EX PARTE STATEMENT

ET DOCKET NO. 01-278
ARRL Ex Parte Presentation¹
to the Office of Engineering and Technology
Federal Communications Commission
February 26, 2002

ET DOCKET No. 01-278
ARRL Ex Parte Presentation²
to the Office of Engineering and Technology
Federal Communications Commission
February 26, 2002

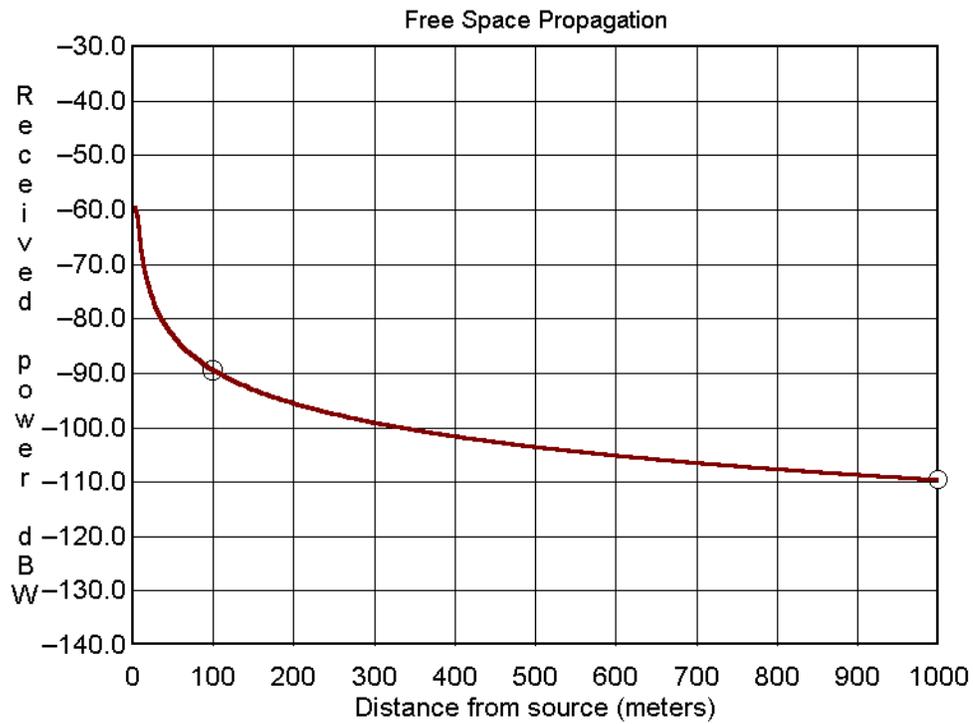
ARRL's curves show data plotted at points from 1 meter to 1000 meters from a source that is radiating an RF signal that would result in a field of 110,000 microvolts/meter 3 meters distance from that radiating source (plane-wave fields assumed). Although it may not be visually evident from the graph, the curve for a 0 dBi gain receive antenna shows the field at 3 meters distance as -58 dBW. This is in reasonable agreement with the figure that SAVI cited for the interrogator, which generates a field of 110,000 microvolts/meter at 3 meters.

The levels SAVI provided for 1000 meters distance, although incorrect because of this initial error, are 20 dB less than the numbers at a distance of 100 meters distance, indicating that they believe that the field follows a $20 \log(\text{distance ratio})$ function. Of note, the test data included with their application for Certification of a series 400 RFID device has a section that discusses how the field varies as $20 \log(D/\text{reference distance})$. SAVI cannot allege (1) that the field varies as $-43 \log(100/3)$ between 3 and 100 meters, and (2) that the field varies as $-20 \log(1000/100)$ between 100 and 1000 meters.

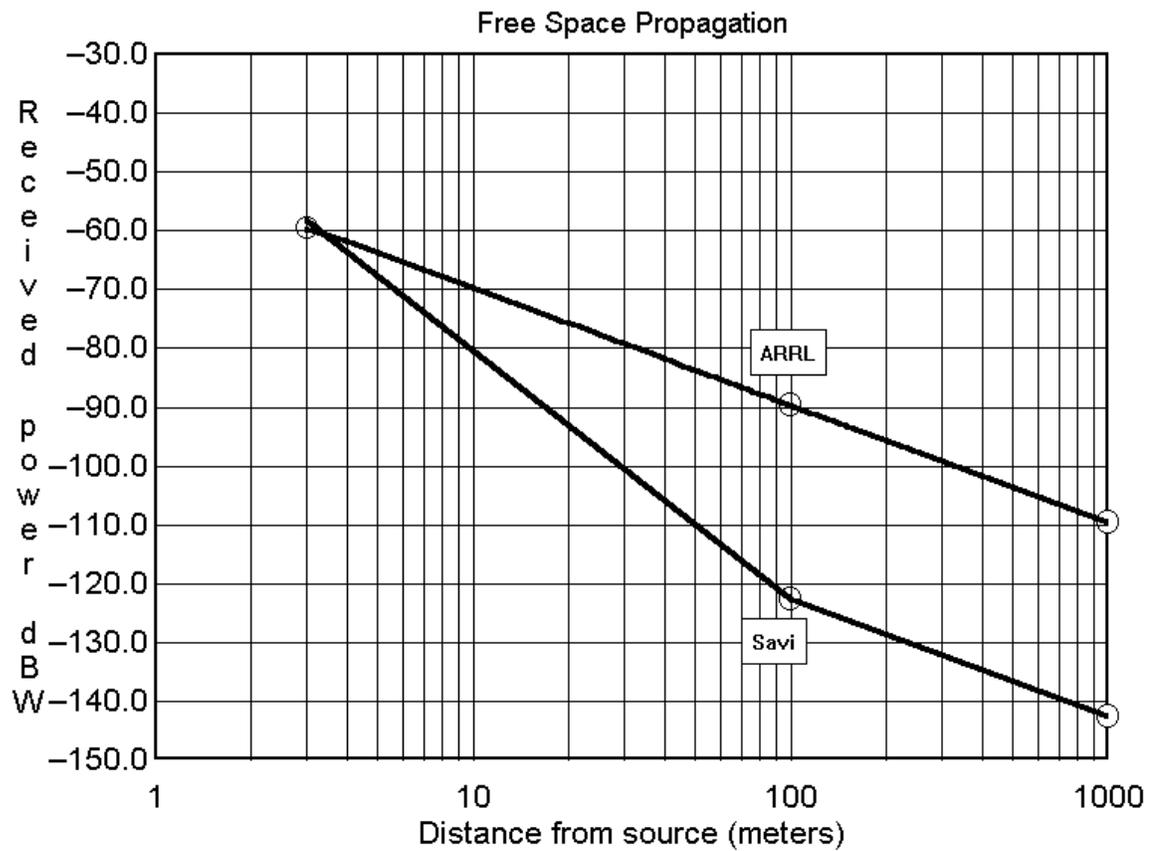
SAVI’s analysis is not self-consistent. Although SAVI and ARRL reach the same approximate conclusion about the amount of power that will be received by an isotropic antenna located at a point where the peak field strength is 110,000 microvolts/meter, SAVI has miscalculated the free-space field that will be present 100 meters from a source that is producing a field strength of 110,000 microvolts/meter 3 meters from that source.

Using Equation 1.0 on 433.92 MHz, ARRL calculates that -89.38 dBW will be produced in an isotropic antenna located 100 meters away from a source that is producing 110,000 microvolts/meter 3 meters distant from that source.

Distance from source	ARRL calculation for power	Savi calculation for power (interrogator)	Notes
3 meters	-58.92 dBW	-58.17 dBW	ARRL and Savi in agreement $-20 \cdot \log(100/3) = -30.46$ dB from the field present at 3 meters. Savi data would require that the field vary as $-43 \cdot \log(100/3)$
100 meters	-89.38 dBW	-122.57 dBW	
1000 meters	-109.38 dBW	-142.57 dBW

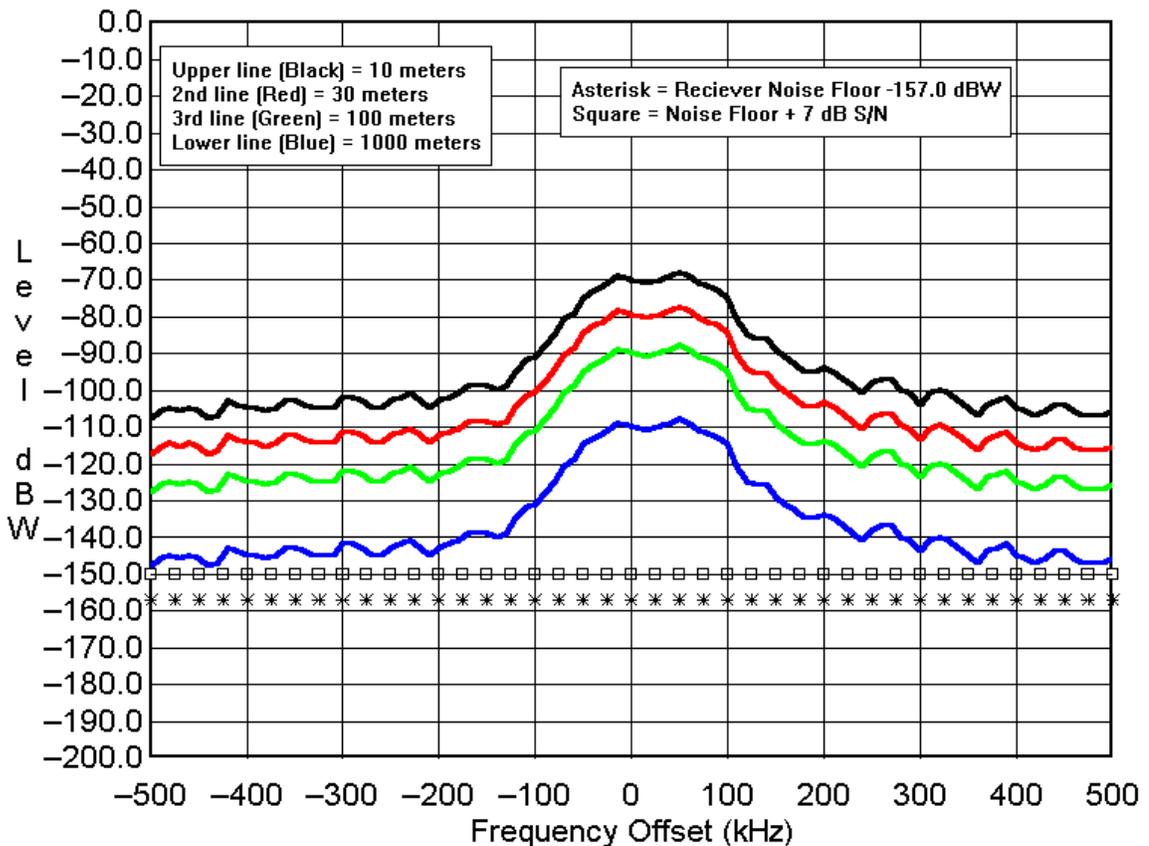
Figure 5 from ARRL’s earlier Ex Parte showed a comparison between the desired minimal FM voice signal in the Amateur Service of –150 dBW and the calculated RFID signal level. Here is the corrected data from Figure 5, designated as Figure 1 in this document.

SAVI claims that at 100 meters separation, amateur signals will be 23 dB higher than the proposed RFID signal. This is incorrect. To obtain this figure, SAVI significantly overestimated the desired amateur signal and made an error in significantly under-calculating that the RFID signal at 100 meters would be at a level of -122.5 dBW. Even in the FM case, had SAVI used the correct calculations to determine the proposed RFID signal level at 100 meters of -89 dBW and used the amateur FM signal level of -150 dBW the resultant $[C(N+I)]$ would be negative. The undesired signal level is 61 dB higher than the desired signal. This is the level shown in Figure 1 of this

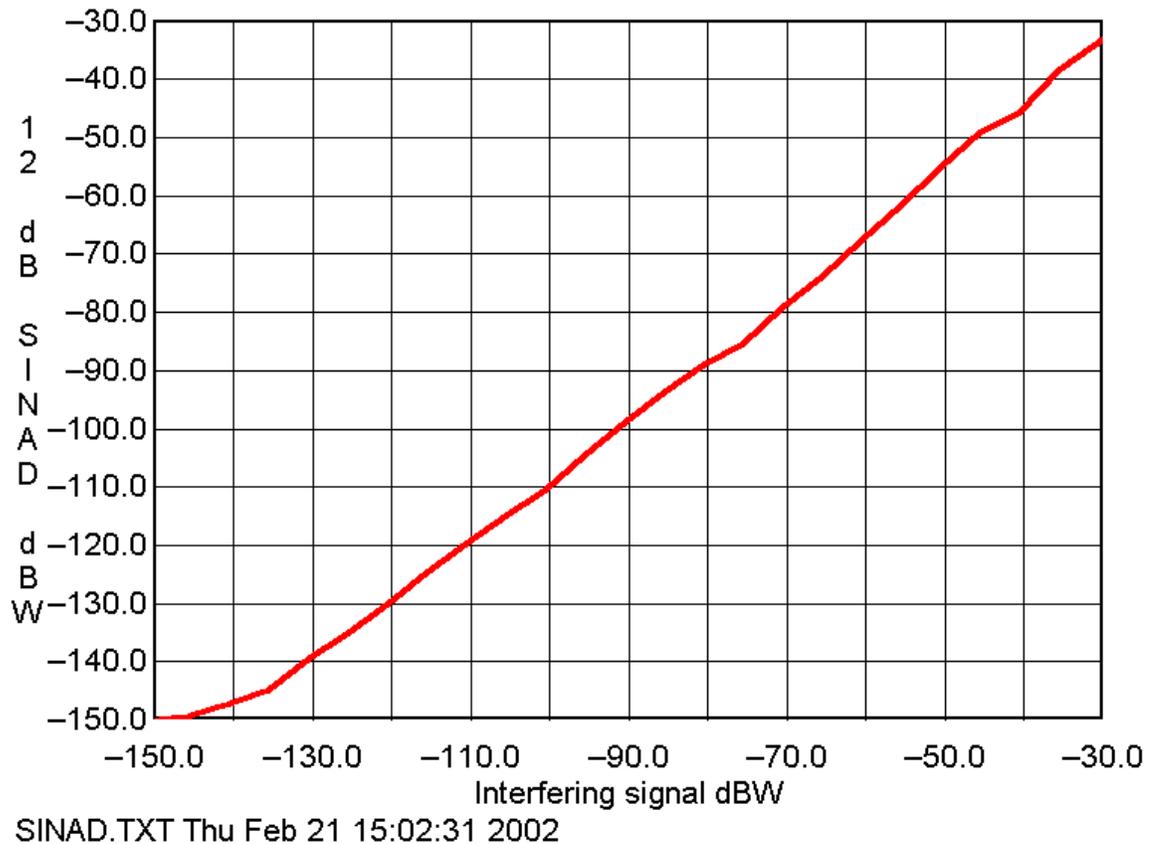
The graph shows about 10 dB of difference between the level of undesired signal and the desired signal. The bandwidth of the undesired signal is 100 kHz while the receiver bandwidth is 15 kHz, explaining 8.2 dB of the difference. The remainder is probably due to the some amount of FM limiting of the noiselike undesired signal. At 12 dB SINAD, there is not much scope for the limiter to work, but some limiting may occur.
